Access Compliance Report Public Rights-of-Way (Pedestrian Signals)

Main Street: ANTONIO_PKWY Cross Street: ANTONIO_PKWY Location: NW

ADA ID: SGRK211116114021 Signal Type: One Push Button-APS Overall Compliance: No Severity Scores: BTN 1: 25 BTN 2: N/A No BTN: N/A

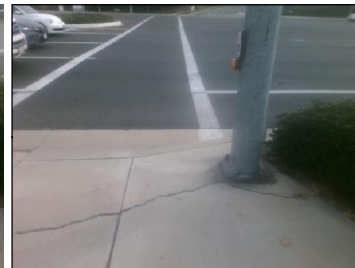
OC Std/PROW: R404.2, MUTCD 4e.12

Possible Solutions: Remove and Replace Clear Space. Align Push Button With Crosswalk.
